From: Amanda Froese [REDACTED]
Sent: Wednesday, November 5, 2025 9:16 AM
To: Candace Hamm <candace.hamm@saugeenshores.ca>
Cc: Coreena Smith <CJSmith@brucecounty.on.ca>
Subject: Two-Zone Policy PIC

From: [REDACTED]
To: [Klarika Hamer](#); [Coreena Smith](#)
Cc: [Candace Hamm](#); [Michael Oberle](#); [Matt Armstrong](#); [REDACTED]; [REDACTED]
Subject: Launch Property Group Ltd. / Meritech comments on L18 Z62 Southampton Two Zone JQ6005
Date: Saturday, April 11, 2026 7:54:26 AM
Attachments: [Grenville Street Floodplain Mapping Update Memo 2026.04.10.pdf](#)

Re: Floodplain Mapping Update – Grenville Street Lots

Figure 2 Proposed Two-Zone Floodplain Mapping - Grenville Street

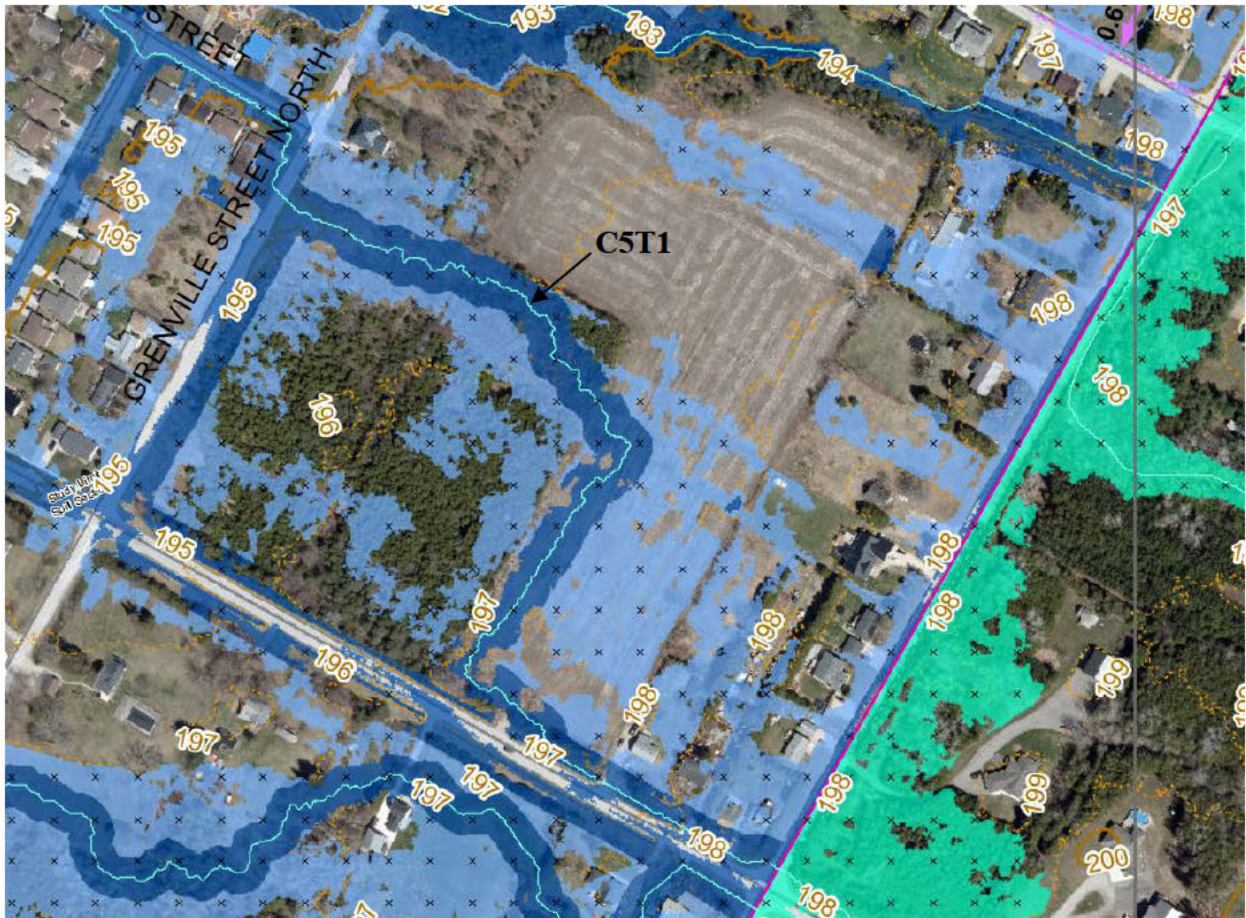
Within the proposed two-zone floodplain mapping, significant portions of the subject lots under development have been identified as floodway due to the existence of a road-side ditch along Grenville Street North, which served as the primary drainage feature (watercourse) for water flowing north-east down Grenville Street North toward the C5T1 watercourse, as well as the C5T1 watercourse itself. As part of the urbanization of Grenville Street North, a storm sewer was constructed, with a curb and gutter system. The road-side ditch was filled in, and the drainage feature along Grenville Street North no longer exists. The current proposed two-zone floodplain mapping is shown below in **Figure 2**, which does not reflect the urbanization of Grenville Street North.

- 4) Prior to approval of the new two-zone floodplain mapping, the floodway associated with the C5T1 watercourse between High Street and Grenville Street, and with the previous road-side ditch along Grenville Street North should be revised such that it is mapped and regulated as a spill.

Figure 8 Regulatory Floodplain Map - not to scale

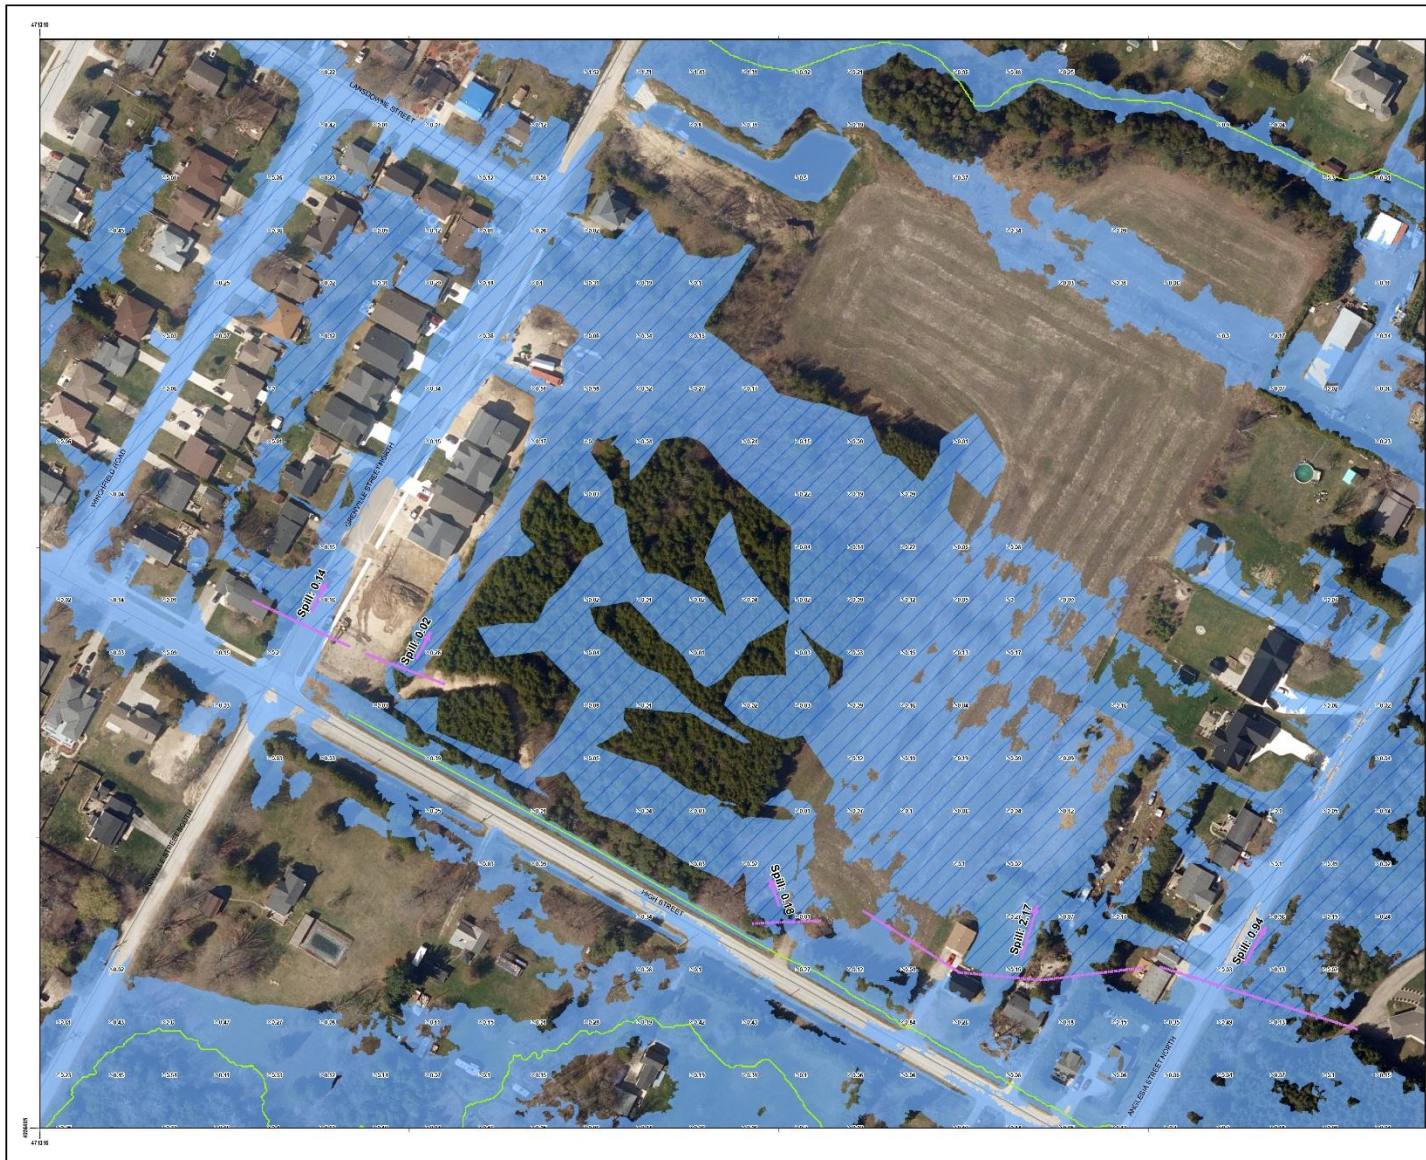
It was determined that the flooding from High Street toward the north-east and north-west should be considered a results of spills from the ditch along High Street, and not a result of riverine floodplain. Five (5) spills have been identified ranging from 0.02 cms to 2.17 cms under the regulatory storm.

- 2) The conclusion in item 1 is valid for both the current one-zone regulatory mapping and proposed two-zone regulatory mapping in Southampton;
- 3) The floodplain associated with the C5T1 watercourse, and previous road-side ditch along Grenville Street, should be classified as a spill area, and regulated as such; and,

Attachment I
Floodplain Mapping

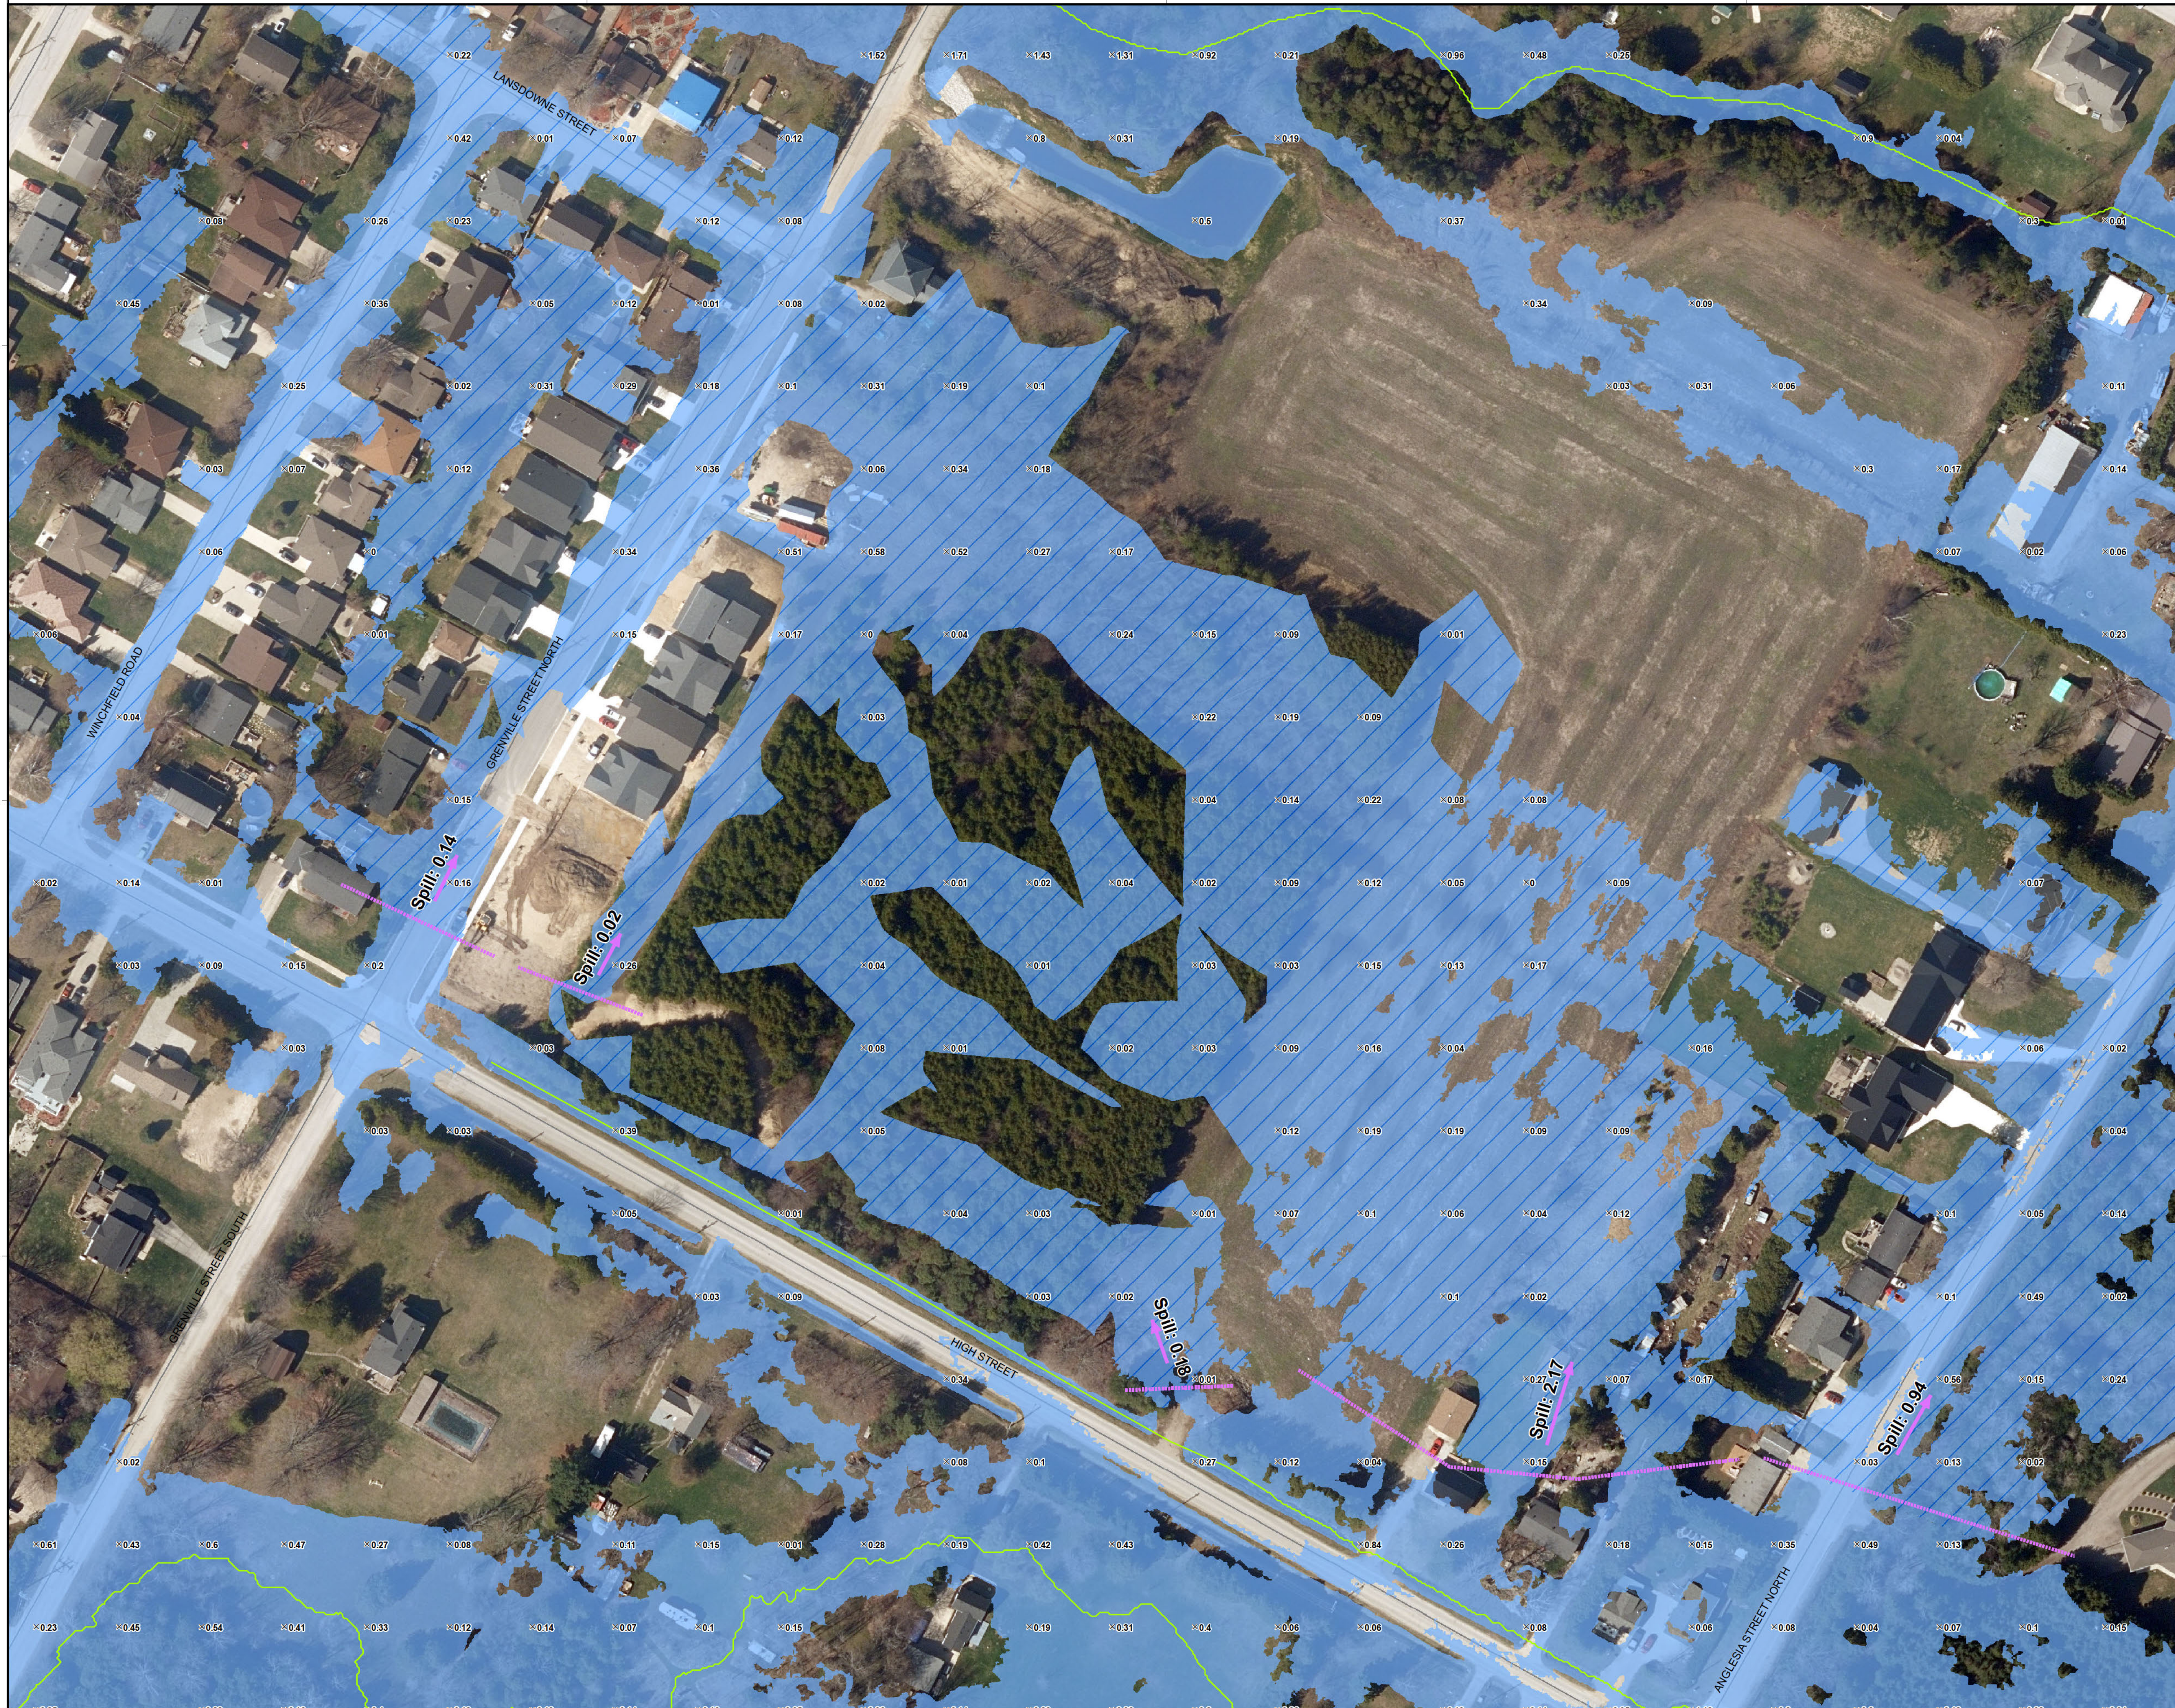
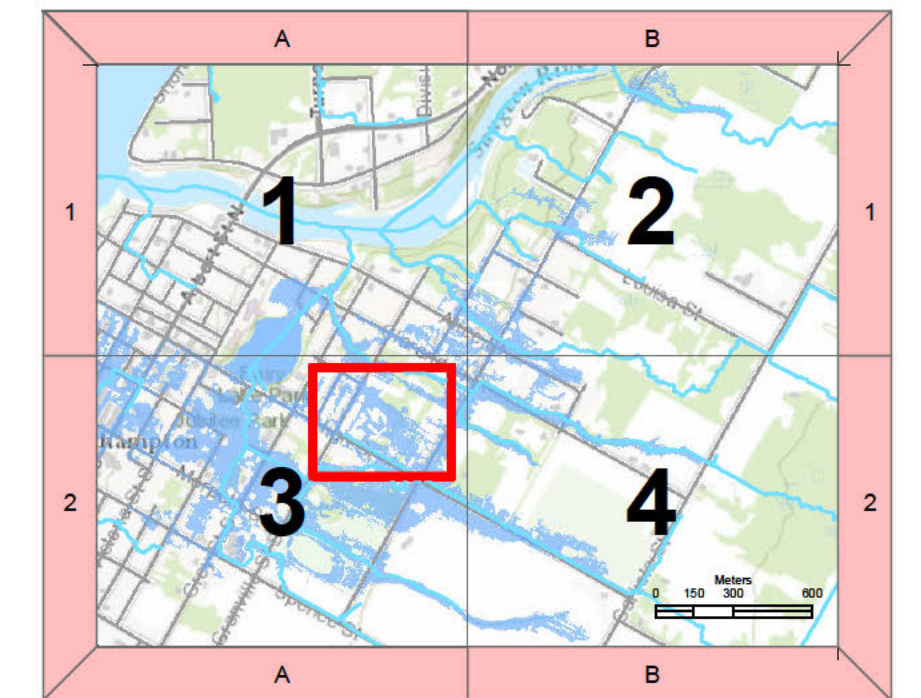
An updated floodplain map for the study area has been prepared, and included in **Attachment I**, A reduced version is shown below in **Figure 8**.
